BURLINGTON DEVELOPMENT REVIEW BOARD Tuesday December 17th 2019, 5:00 PM Contois Auditorium, City Hall, 149 Church St, Burlington, VT AGENDA

TO: Development Review Board
FROM: Scott Gustin
DATE: December 17, 2019
RE: 20-0534SP; 362- 374 Riverside Avenue

Request: Sketch plan review of 65-unit senior housing building and related site improvements

Layout and
Materials Plan

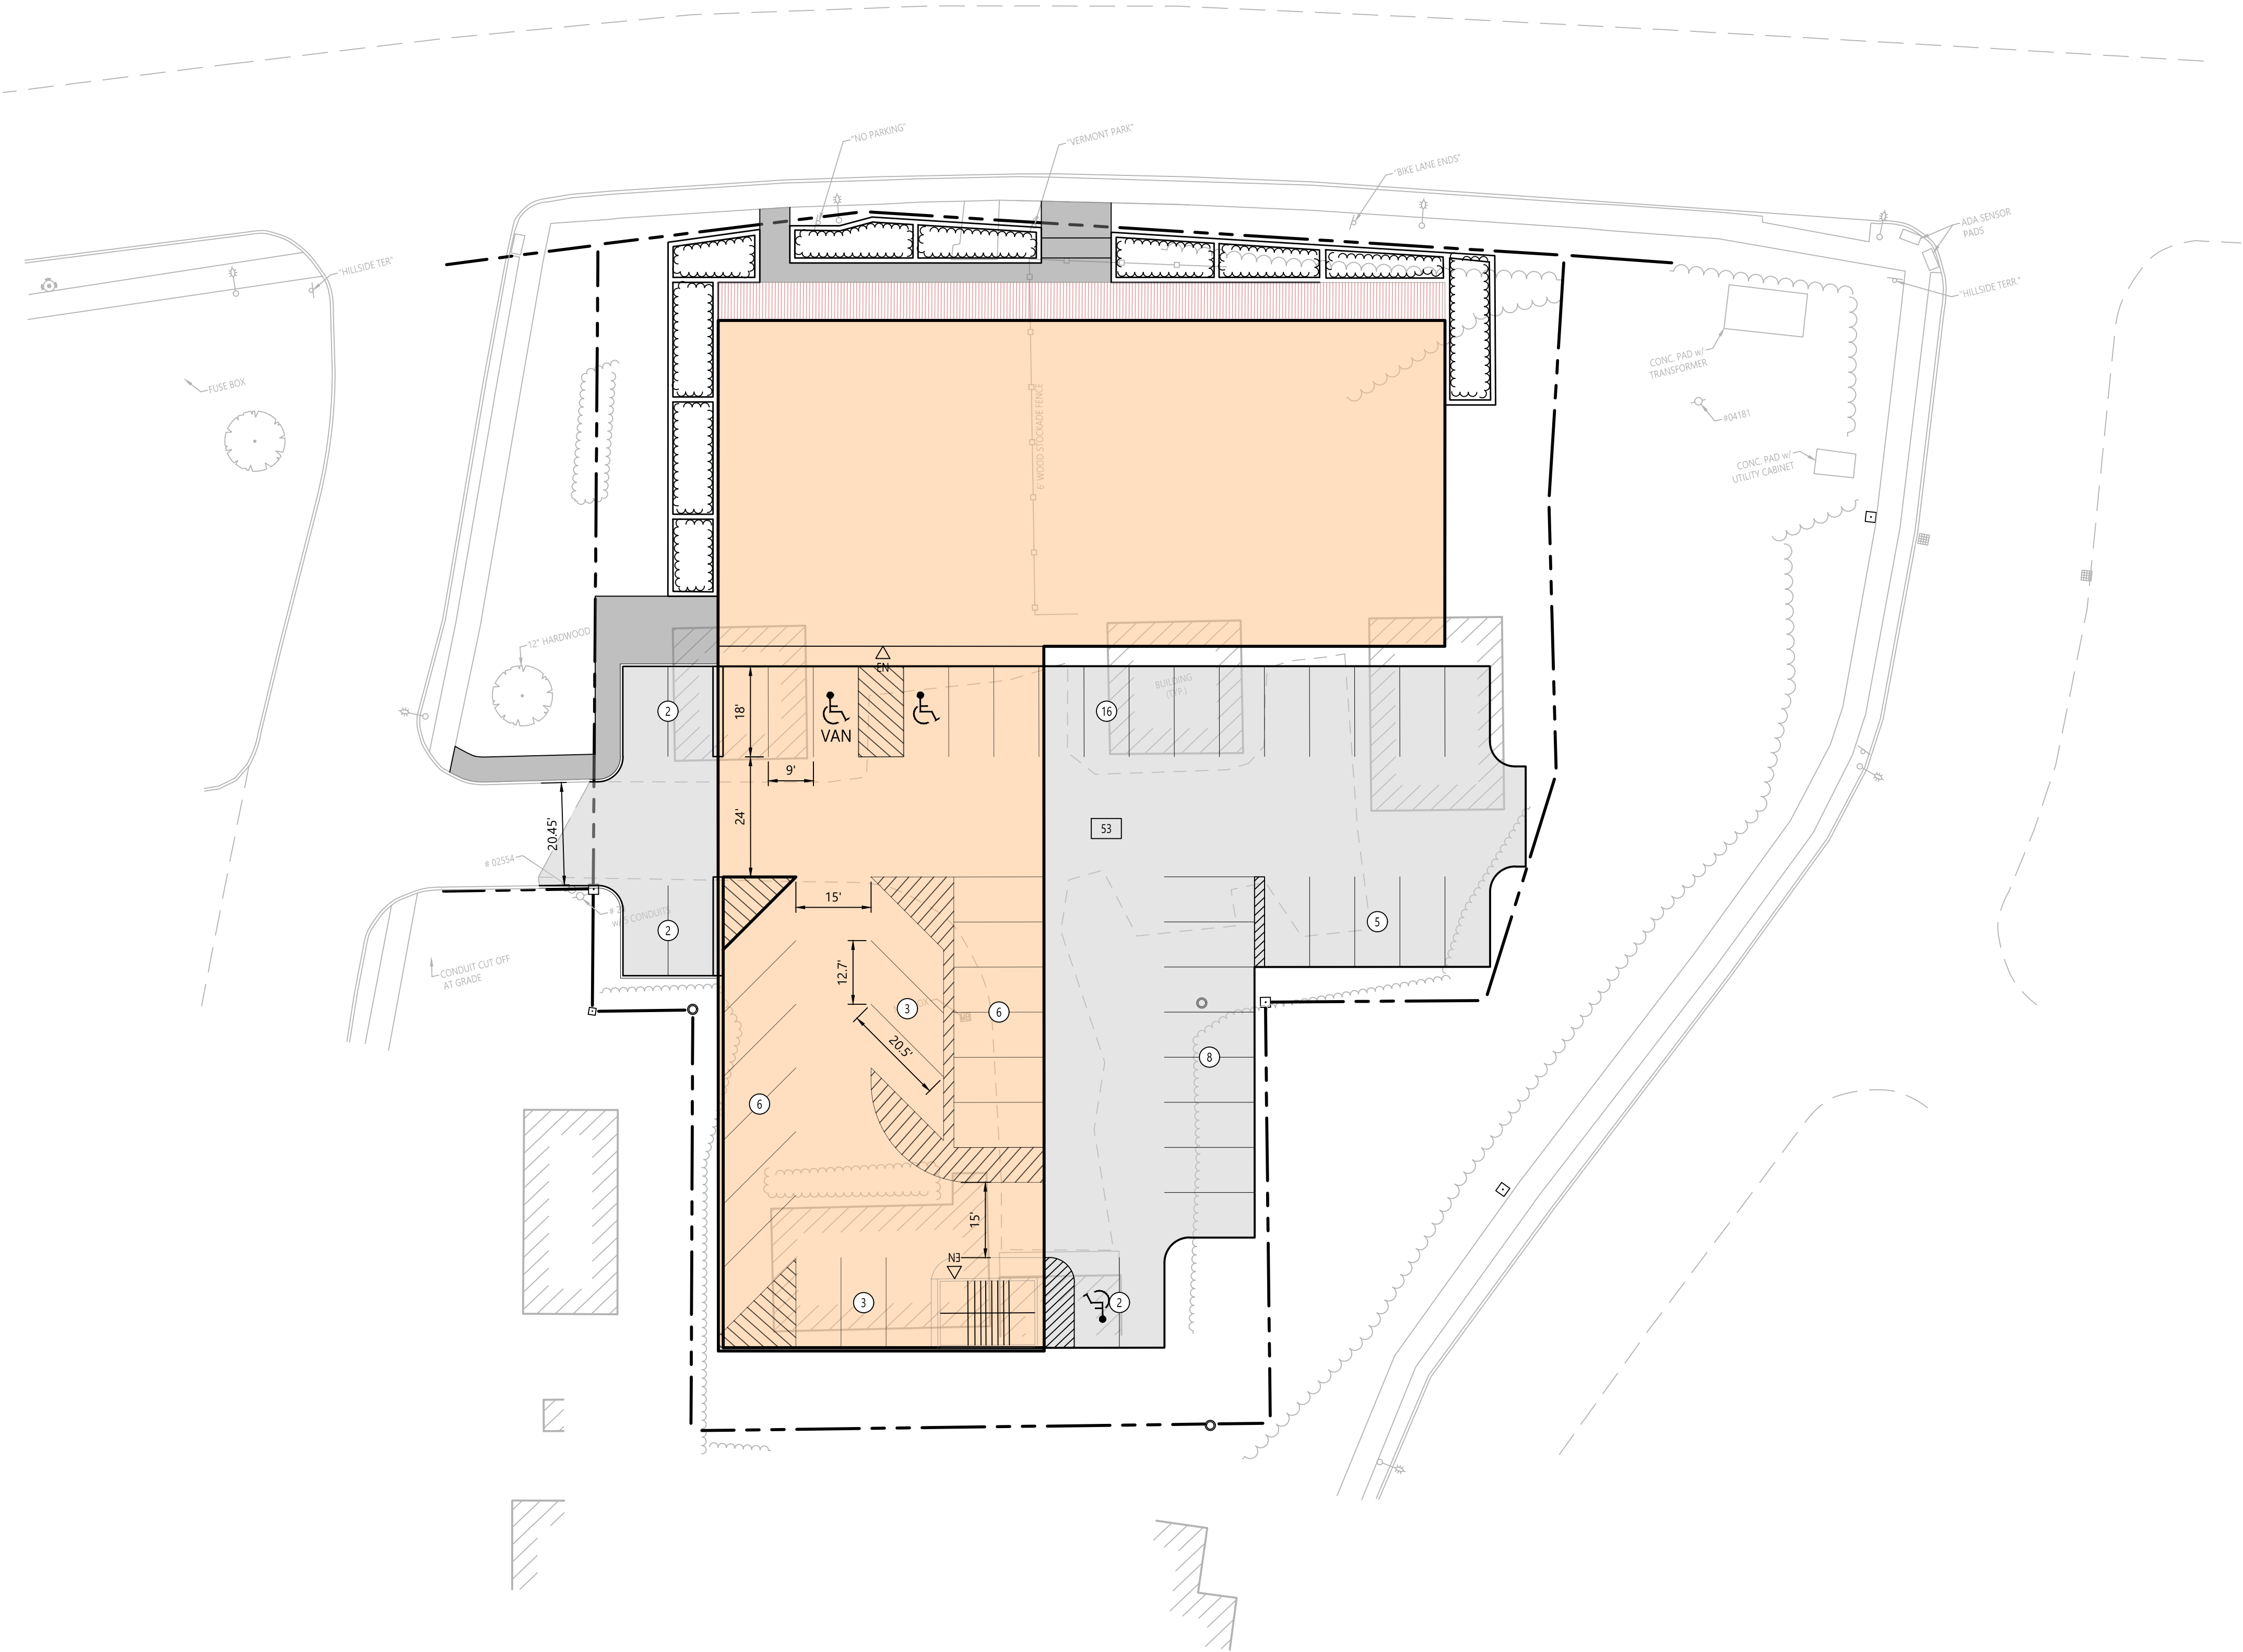
The sketch plan lacks much in the way of detail; however, it does depict the new building set close to Riverside Avenue. A new walkway will connect an apparent center entryway to the public sidewalk along Riverside. Parking appears to be set behind the front half of the new building. Given the U-shape of Hillside Terrace, the new building will face Hillside Terrace to the east and west and Riverside Avenue to the north. All three street frontages of the proposed building will need to be sensitively designed to provide an active and inviting street edge.

Vehicles will access the site as they presently do from the western section of Hillside Terrace. It is the eastern section of Hillside Terrace that has a signalized intersection with Riverside Avenue. Seemingly, use of the signalized intersection would be preferable. Comment from the Department of Public Works will be significant in this consideration.

A public sidewalk runs along the length of Riverside Avenue and Hillside Terrace. The sketch plans depict walkways connecting to both Riverside Avenue and to the western section of Hillside Terrace.

Handicap parking spaces are depicted in the sketch plan. Two of the three are located within the garage. It is the applicant's responsibility to comply with all applicable ADA requirements.

As noted above, parking will be set behind the front half of the proposed building and appears to be enclosed as viewed from the western section of Hillside Terrace. Screening of the surface parking as viewed from the eastern section of Hillside Terrace will be needed.

The subject property is located in the Shared Use parking district. As such, it requires 1 parking space per dwelling unit. As proposed, 53 parking spaces are proposed for the 65 dwelling units. A 12-space parking waiver will be needed per the standards of Sec. 8.1.15.

Two ADA parking spaces are depicted within the garage. A third space is depicted within the surface parking area. These spaces shall be marked and signed as required for handicap spaces.
